TOWNSHIP OF FRANKLIN
Board of Adjustment
Agenda
Thursday, October 15, 2026

KYLE PORTER / ZBA-26-00019

TAWHEED DAHWAH CENTER / ZBA-24-00017

Re: Tawheed Dahwah Center – Amended Preliminary and Final Site Plan + Relief of Condition (ZBA-24-00017)¹
630 South Middlebush Road (B 37.02,0 Lot 46.03)

2 Front Elevation
1/4" = 1'-0"

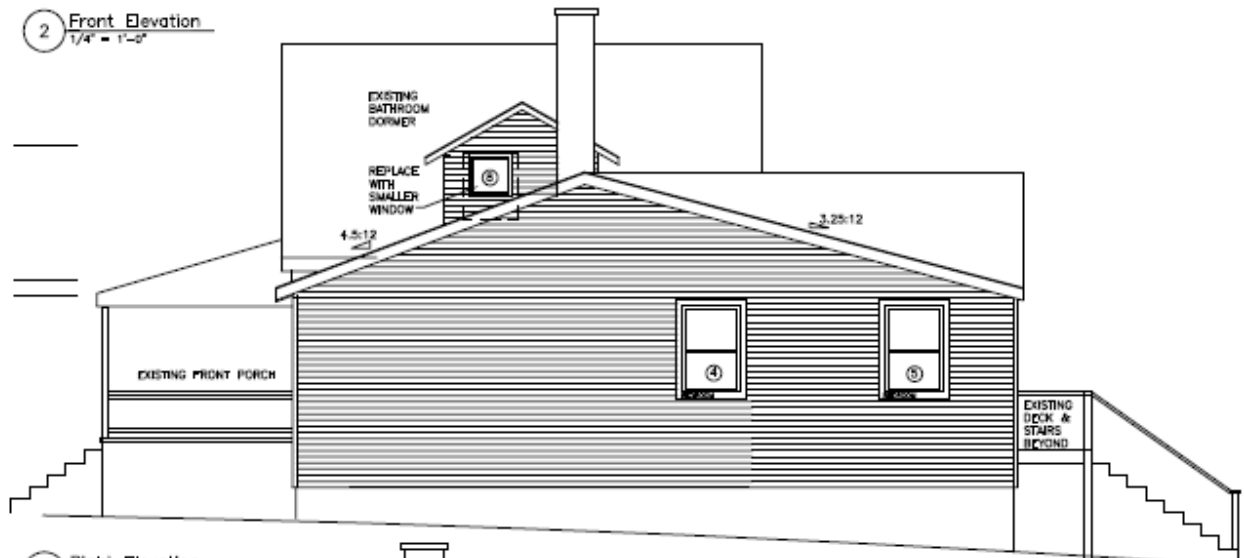
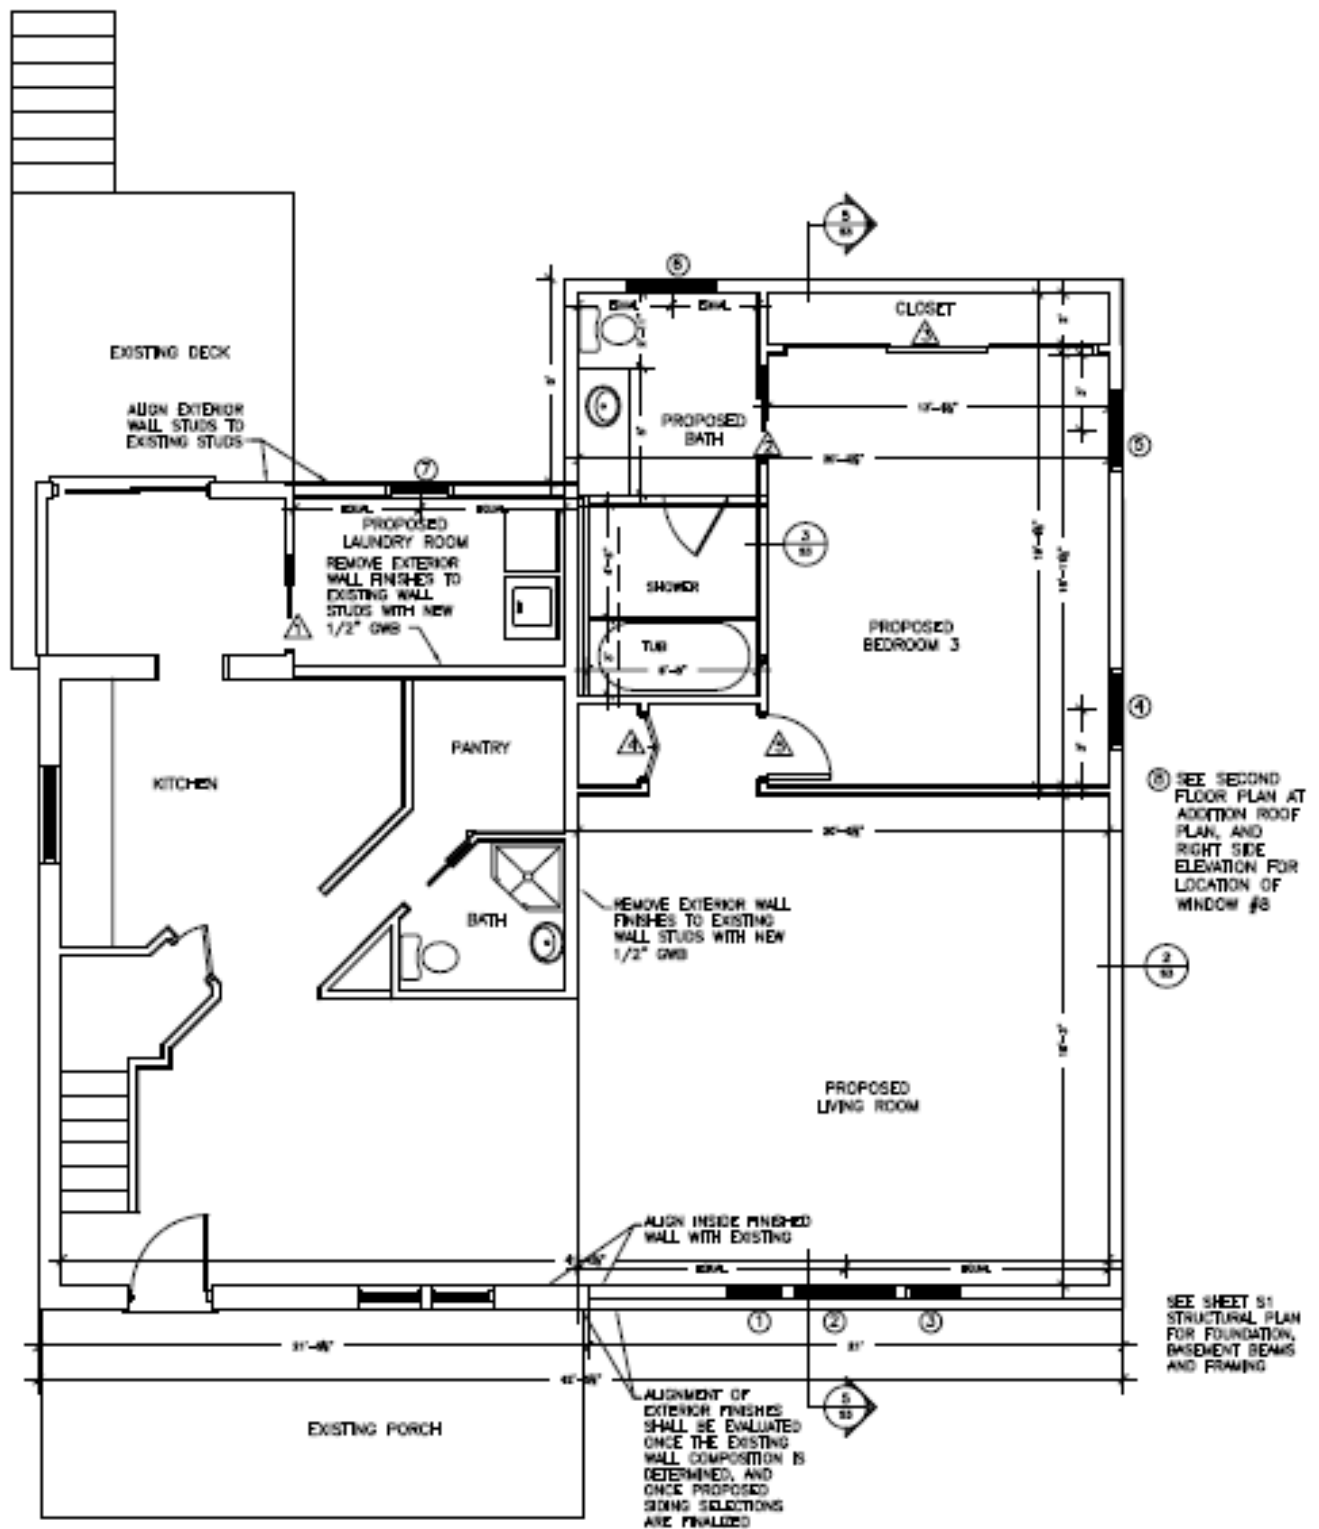
1. With respect to the requested 'c' variances, the applicant needs to demonstrate, to the Board's satisfaction, whether each would satisfy the c-1 (hardship) and/or c-2 (advancement of the MLUL) criteria. With respect to the negative criteria, the applicant must demonstrate that the variances would not result in substantial detriment to the public good ("1st prong" of negative criteria) and will not substantially impair the intent and purpose of the zone plan and zoning ordinance ("2nd prong of negative criteria). Finally, the applicant must prove that

2. The survey needs to identify the location of the well.
3. Note: It appears that the proposed improvements would add less than 1,000 square feet of new impervious coverage. However, if more than 1,000 square feet of new impervious coverage were to be created, the applicant would need to address the requirements of Section 330 of the Township stormwater ordinance for minor developments. These requirements include infiltration of all runoff from the new impervious surfaces via a device such as a drywell or a rain garden. Geotechnical information, a maintenance manual and a maintenance agreement would also be required.
